Built Heritage Sub-Committee / Sous-comité du patrimoine bâti
September 14, 2017 / 14 septembre 2017

Ward: RIDEAU-ROCKCLIFFE (13) **File Number:** ACS2017-PIE-RHU-0018

SUBJECT: Application to Alter 227 Mackay Street, a property located in the New Edinburgh Heritage Conservation District, designated under Part V of the *Ontario Heritage Act*

Document 4 – Foundation / Basement Conditions

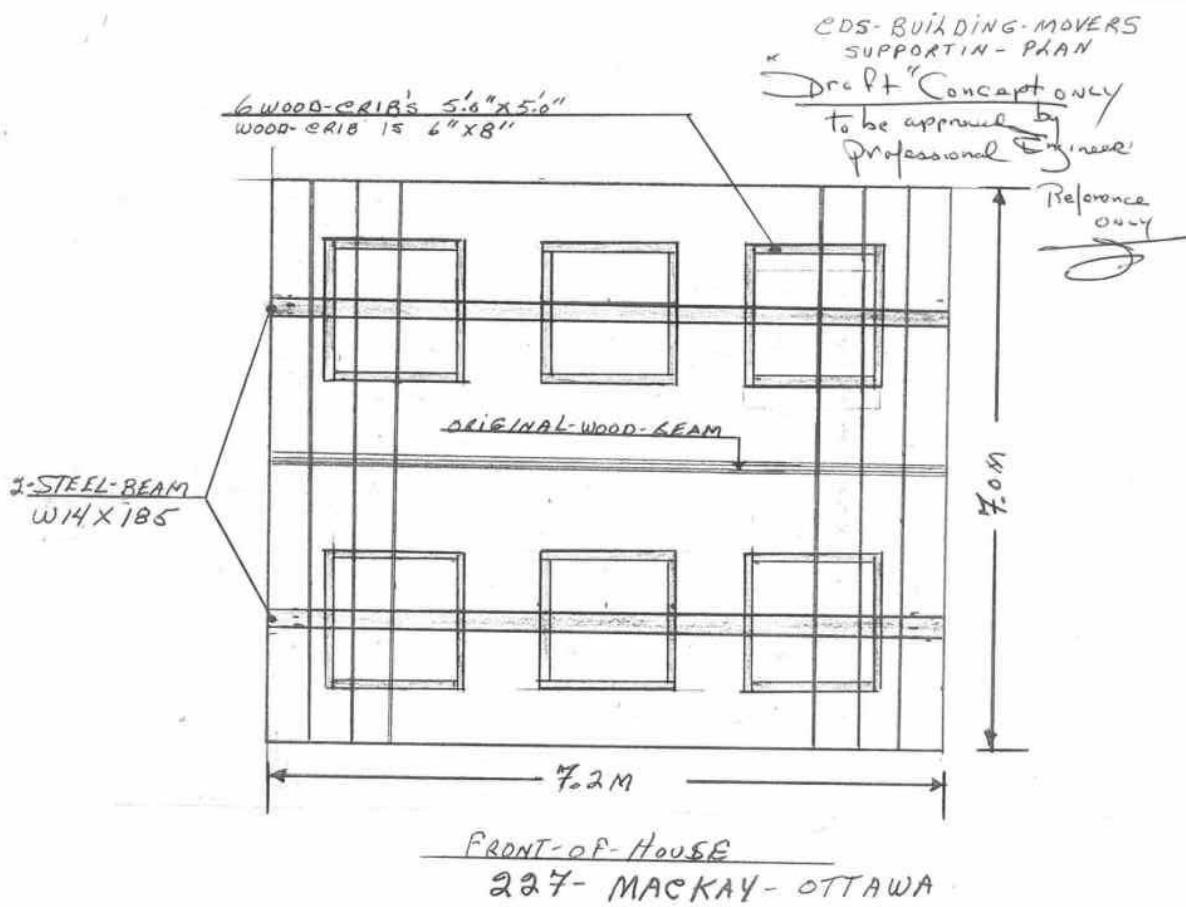
Deteriorated Exterior Concrete Sills

The 1890's house foundations are likely the original foundations as they demonstrate the weather damaged exterior concrete sill shelf detail, which characterized 19th and early 20th century homes often designed for a brick veneer, but which were subsequently changed to wood siding clad construction, to save money. This resultant concrete shelf detail is a serious defect in these homes, as exposed concrete shelves of this nature only attract rain water and shelter moisture which under repeated freeze/thaw cycles of the Canadian Winters, lead to early deterioration of the concrete building element.

Insufficient Soil Cover

The building's basement level inside, has a maximum 6' clear ceiling height beneath the floor structure, and the elevated ground floor which is about 1.0M above the exterior grade, means that the foundations bearing on a moisture laden limestone shale rock, will be continually subject to 'ice lensing' and the subsequent heaving of exterior foundation walls. It is OBC Ottawa structural practice to correct this deficiency by assuring foundations have a 1.6M exterior soil cover. Failure to correct this problem would lead to extensive new and existing building deterioration.

Water Permeable Floor and Walls

The existing house basement floor has continuously demonstrated surface water on the floor. The source of this water is a combination of Ground Water from around the building, and sub surface water which drains on top of the permeable shale rock from Rideau Hall property to the North towards the Rideau River to the South. The possibility of Rideau River flood plane water migration from the South might also exist. Inadequate sub-slab drainage has led to the continuous presence of mould in the basement area.

Deteriorated and Crumbling Concrete

For site mixed concrete used in the 1800's it is not unexpected that any improper mixture of sand and cement in the on-site pour, would result in an early deterioration of the walls in any individual area. The East wall of the foundation has breaches where a reinforcing rod can be pushed entirely through the foundation wall and once the exterior skin is breached, a weak sand/cement dry mixture flows out of the wall penetration. This characteristic common in the joints of stone and brick structures after 100 years of life that require joint bedding replacement, deterioration in parts of these foundations are at the extreme level of failure risk, and are largely incapable of continued support of this residential structure. Breaking the foundation skin reveals a sand and cement mix that crumbles in hand and in some instances, flows out through the exterior foundation parging repairs.

Document 10 – Site Plan (Please note that garage is not within scope of the current application)

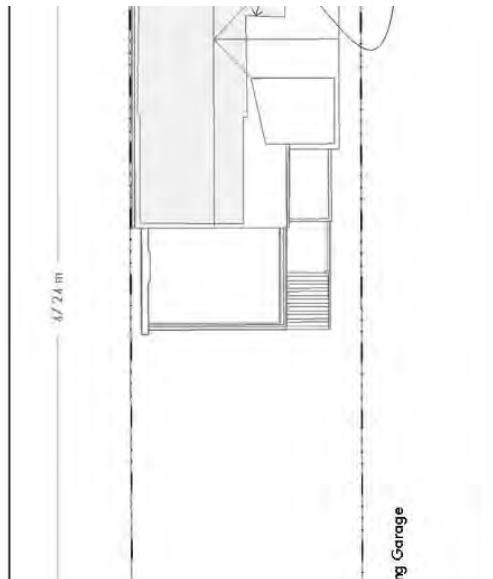
The through lots in the HCD and open, green backyards are attributes of the HCD. The footprint of the proposed building is larger than that of the current building and its additions, however, the new proposal retains an open space to the rear of the building. (See Site Plan, Document 10 and current view of back yard, Document 11)
